PENTON RESIDENCE
23160 LOWE DAVIS RD
RENOVATION/ADDITION PLANS
COVINGTON, LA.

REVISION DATES:		
No.	DATE	PURPOSE
1	5-24-22	REVIEW COMMENTS ADDRESS

SHEET:	A202
OF	-

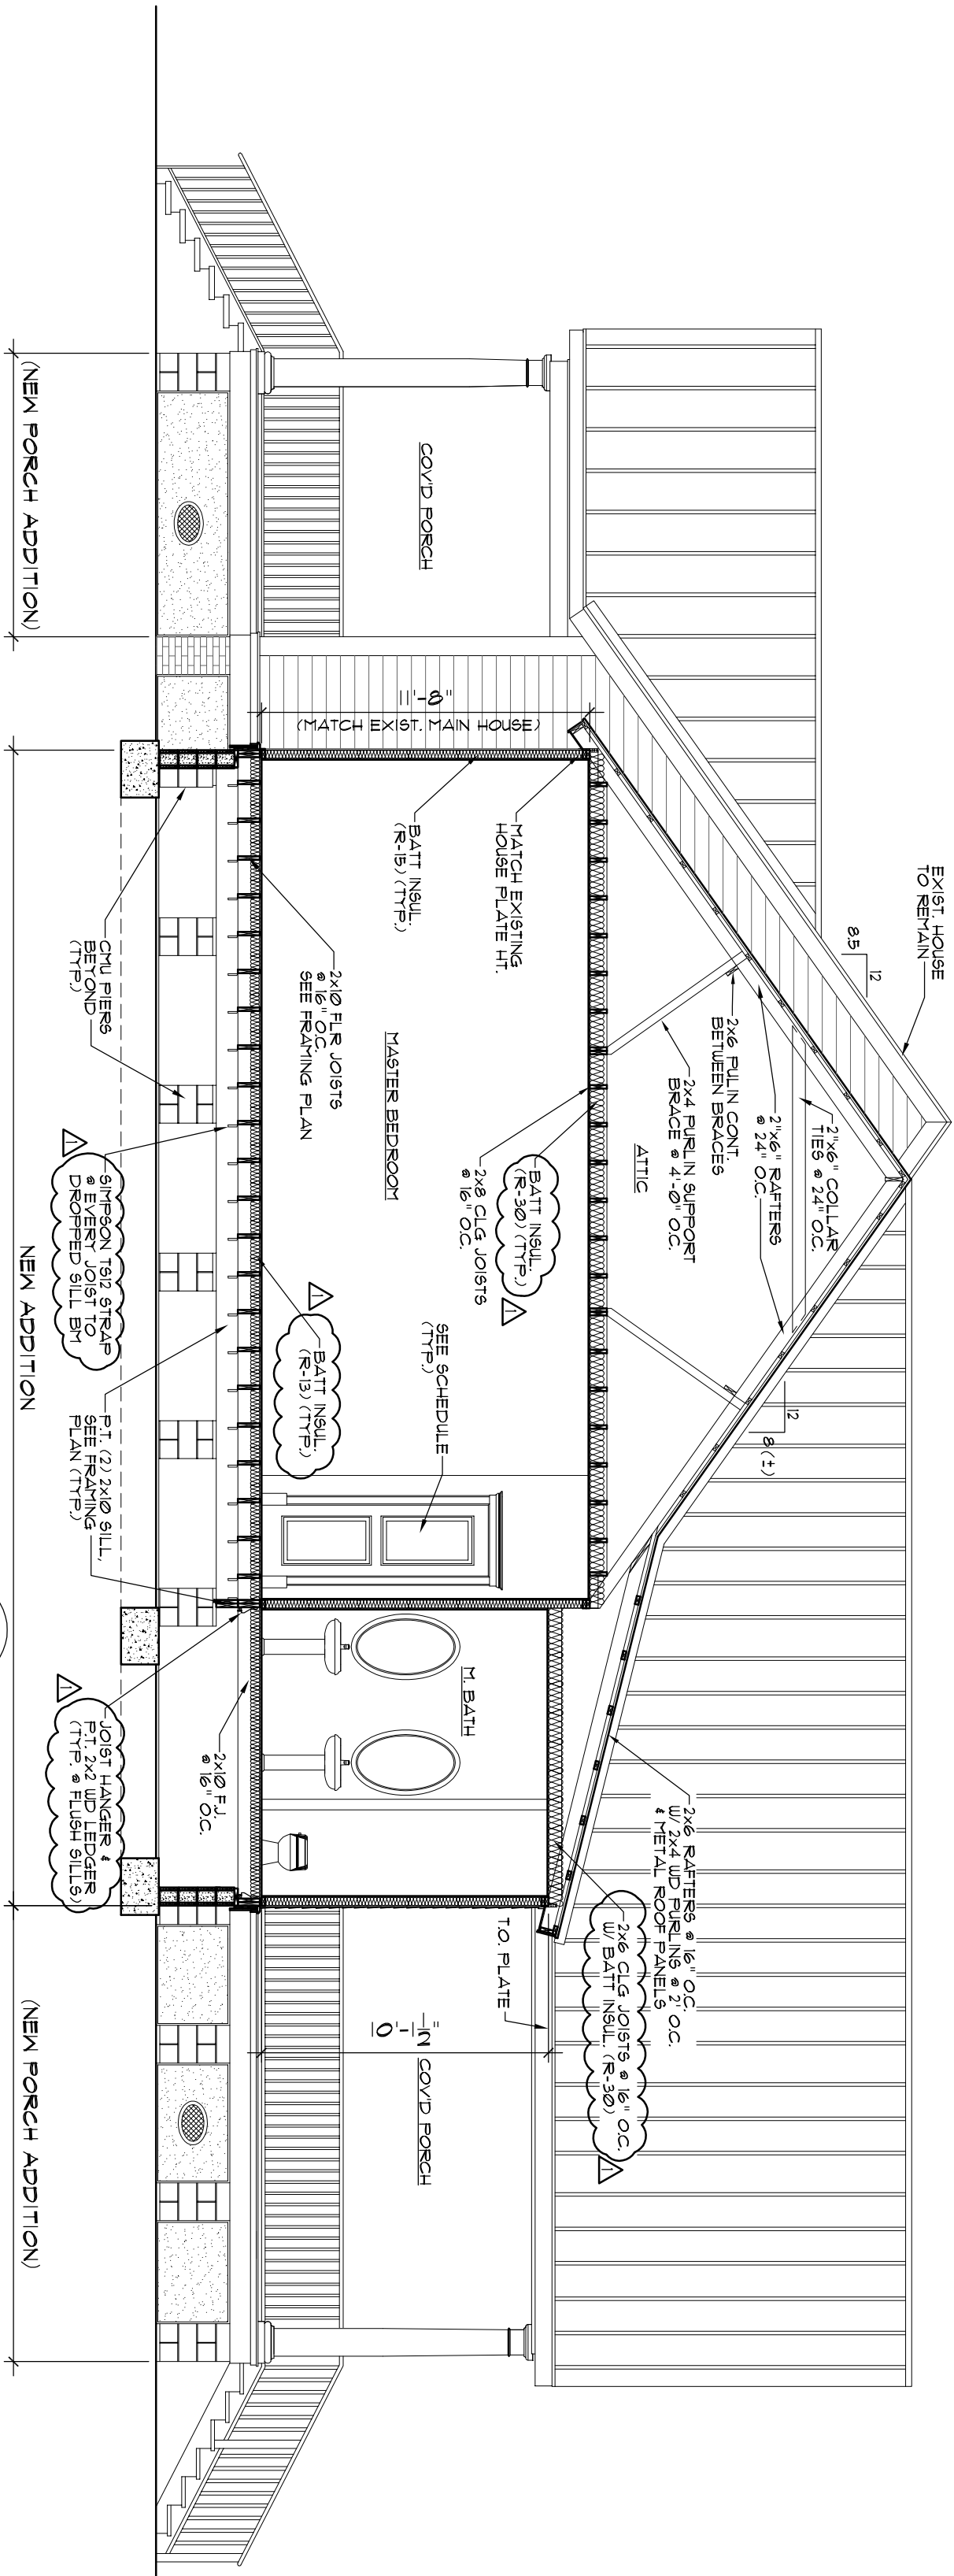
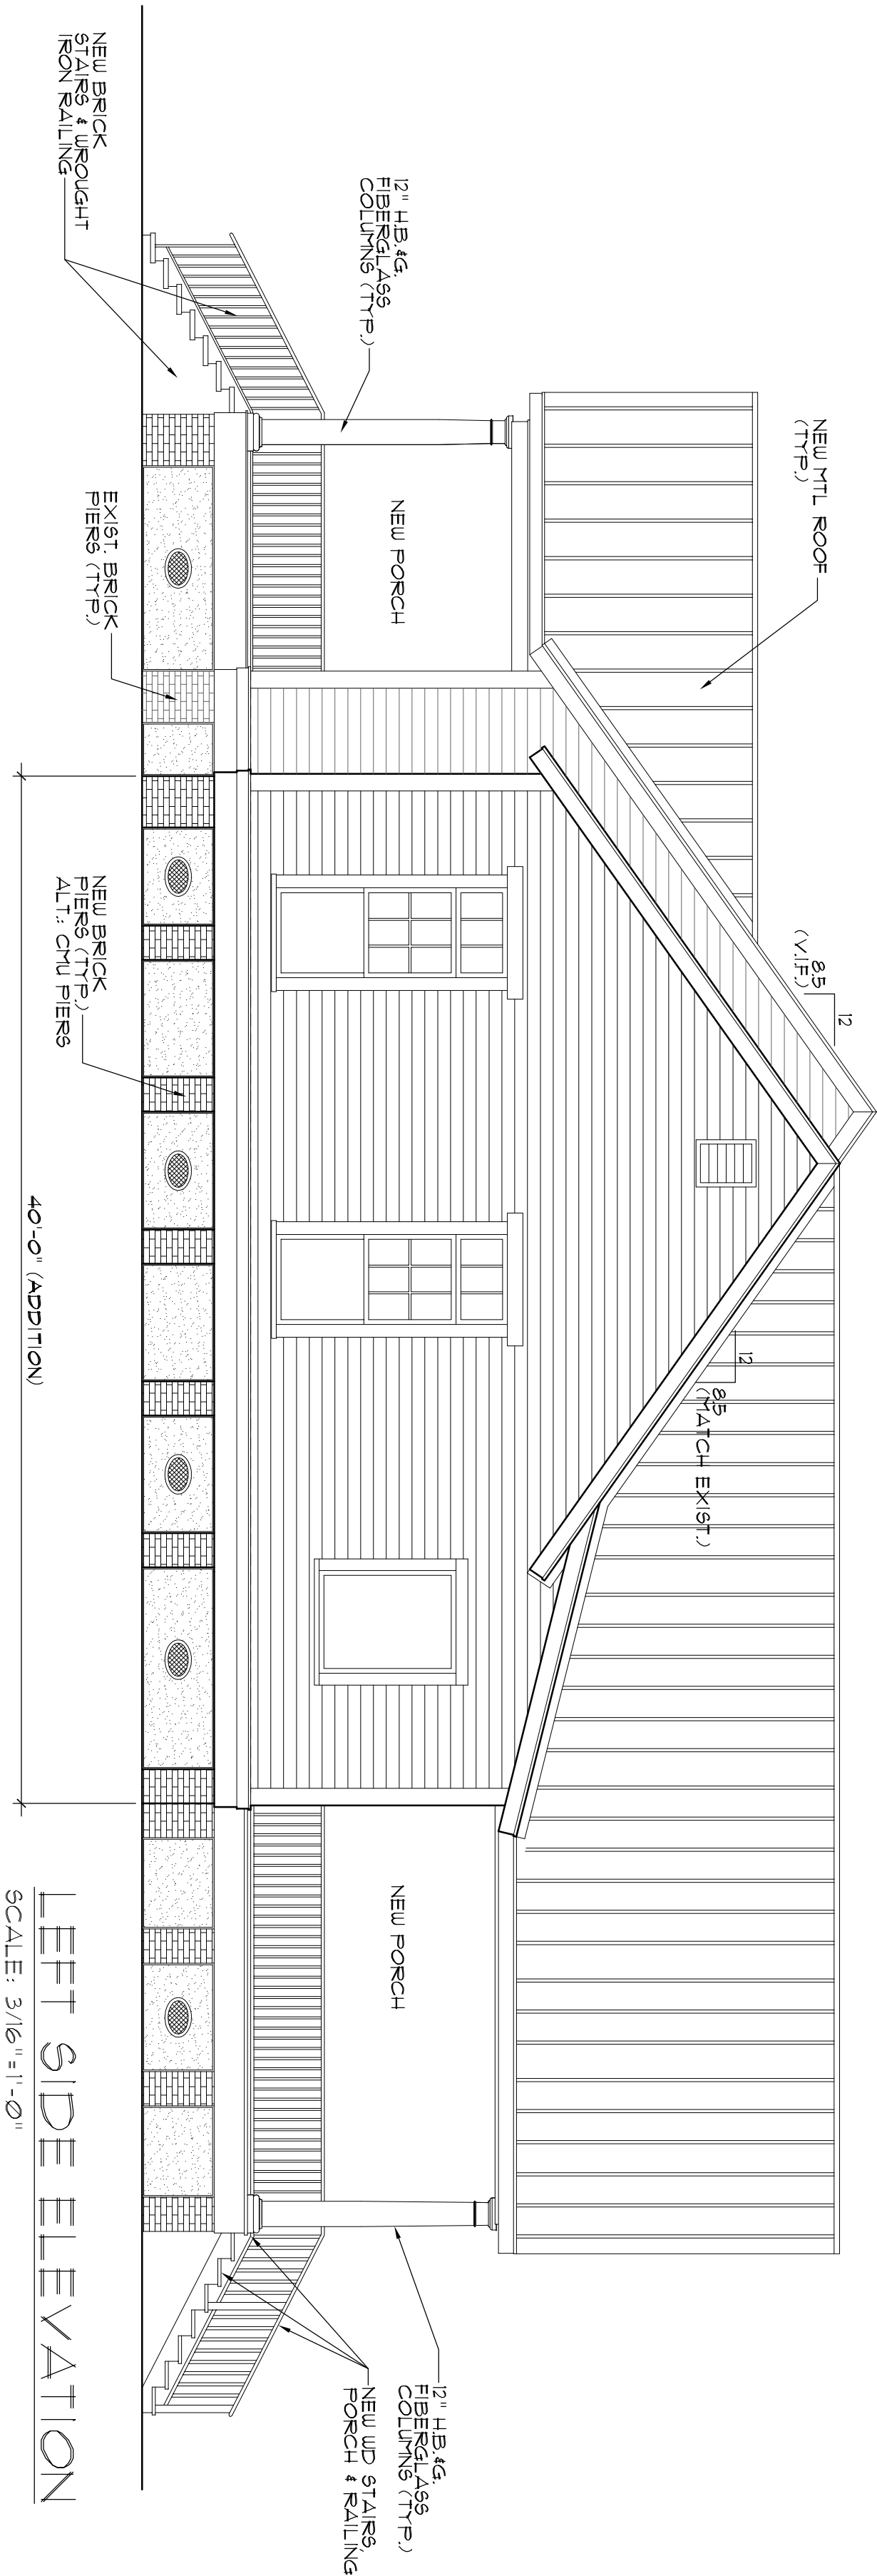
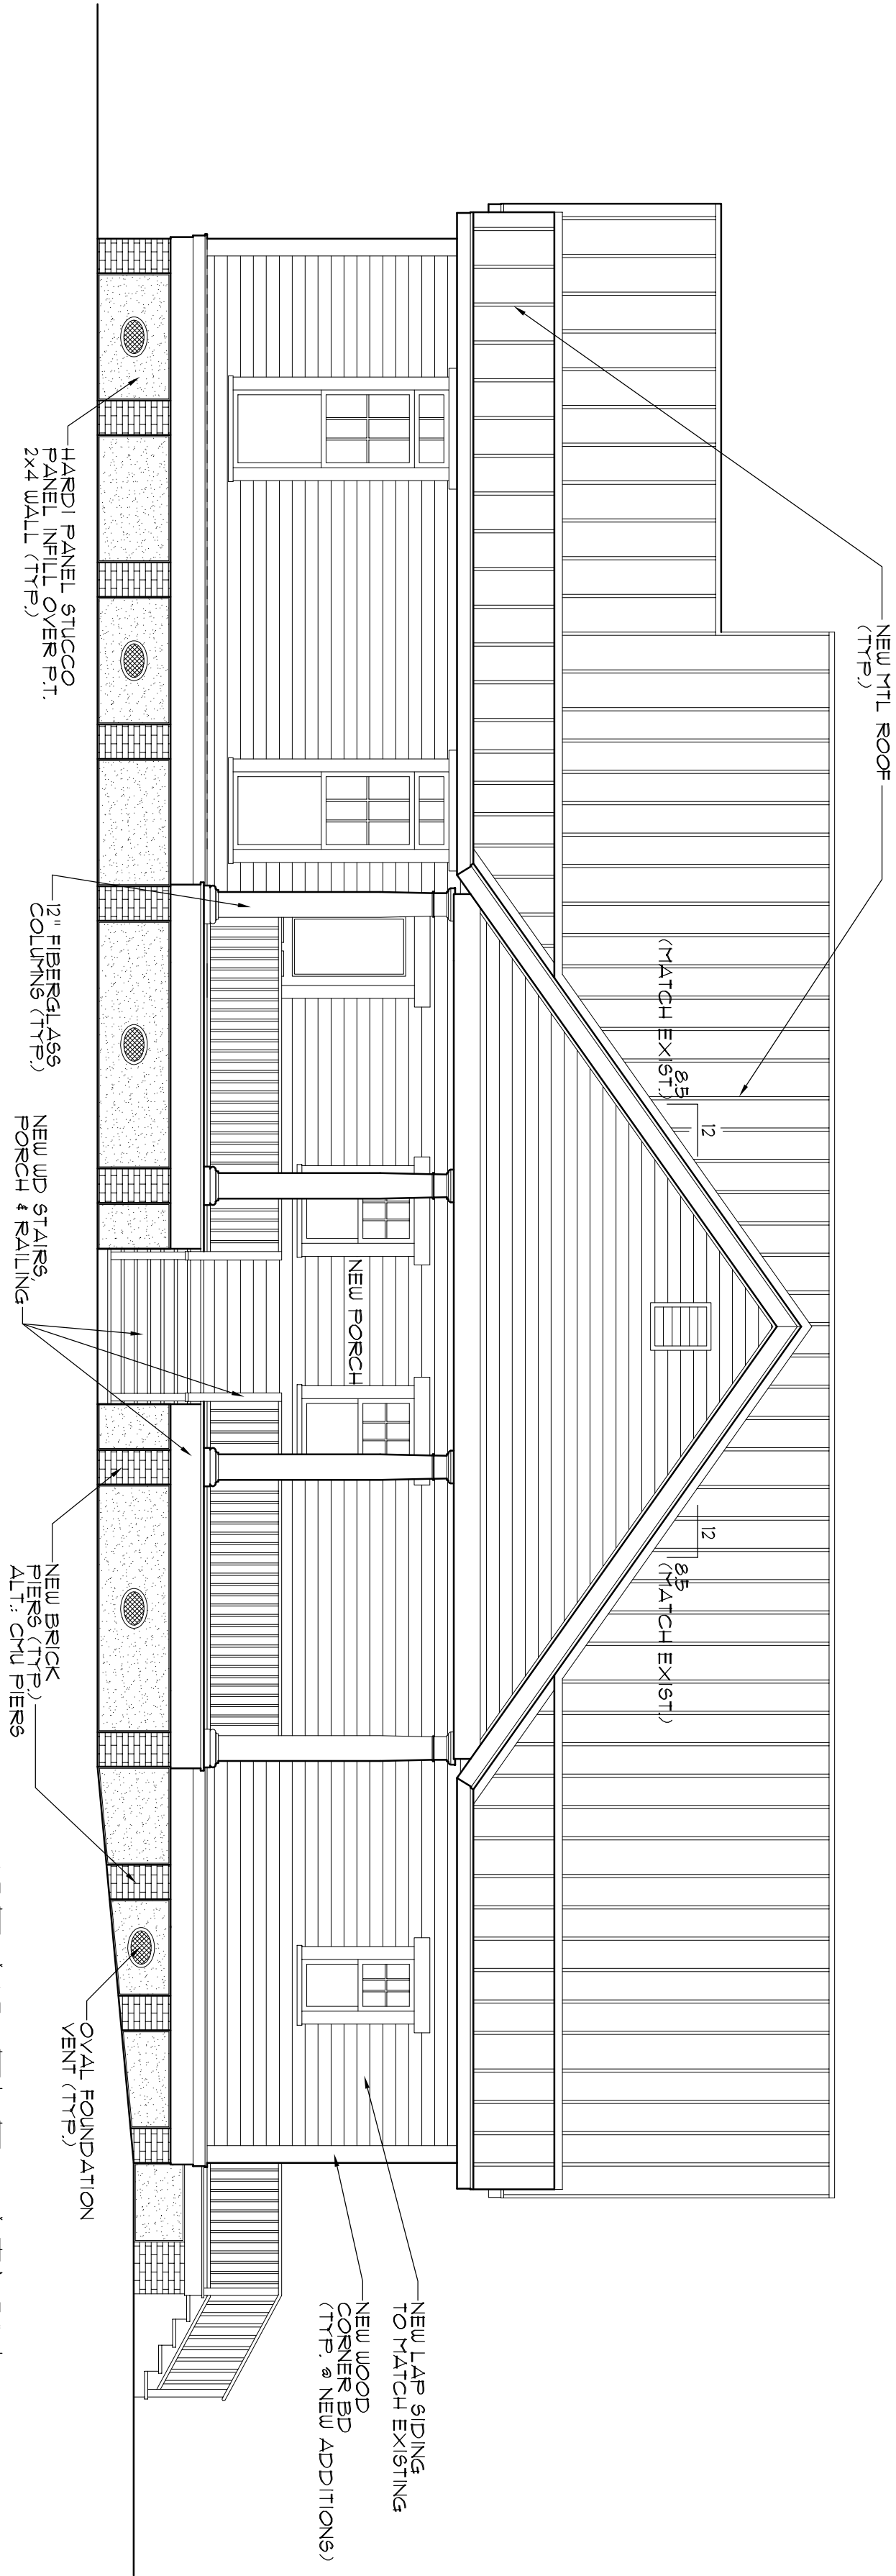
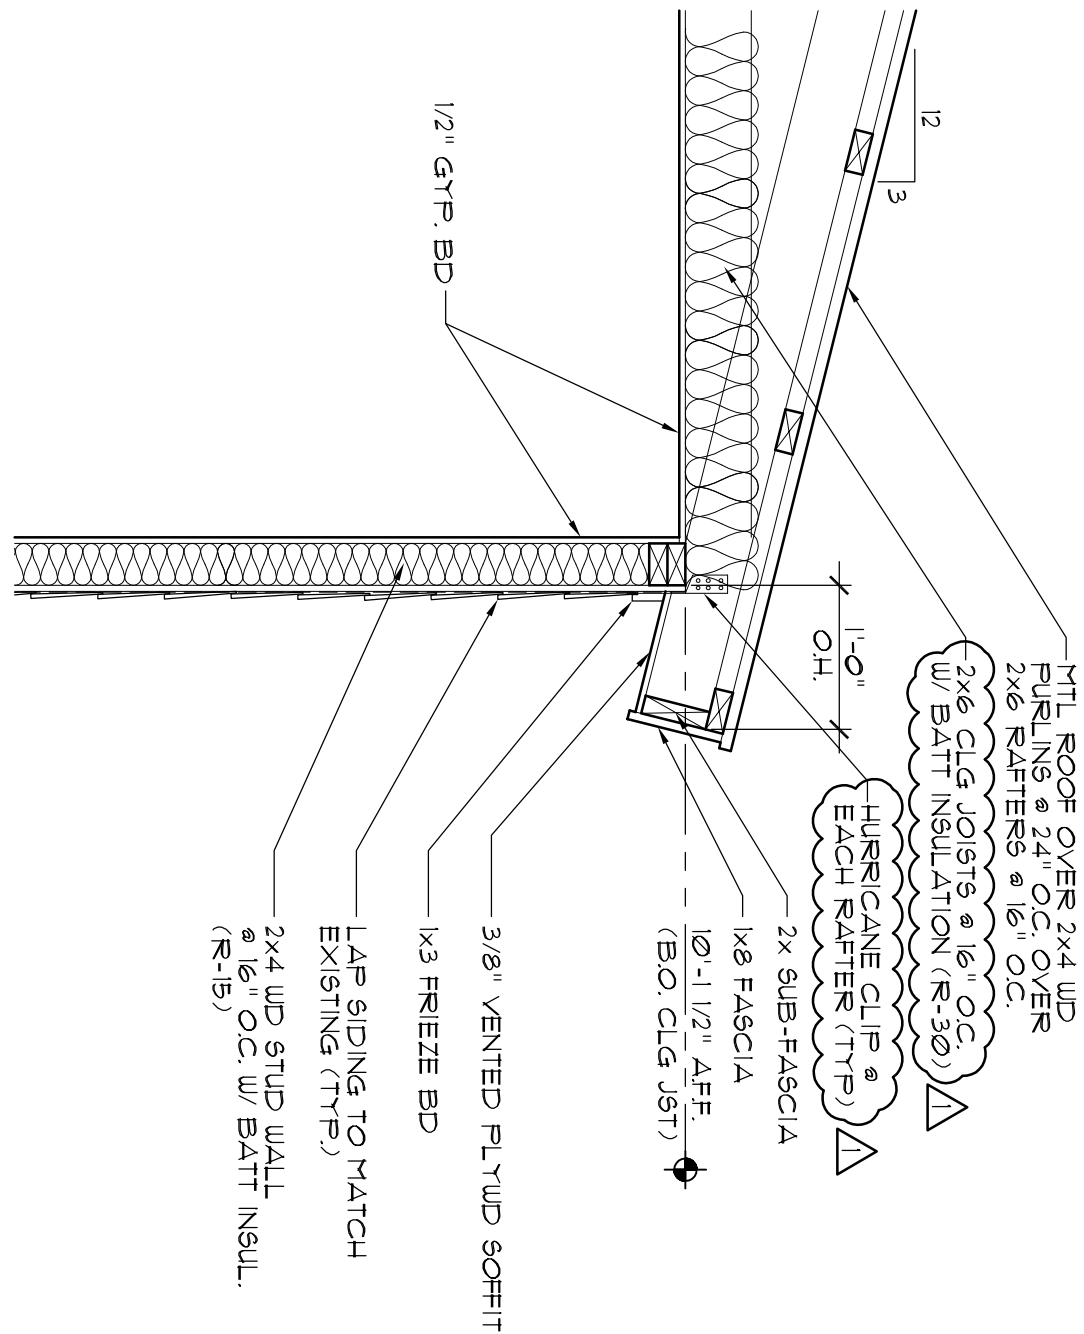
CEILING INSULATION CHANGED TO R-30.
R-13 INSULATION ADDED TO FLOORS.
JOIST HANGERS & STRAPS ADDED.
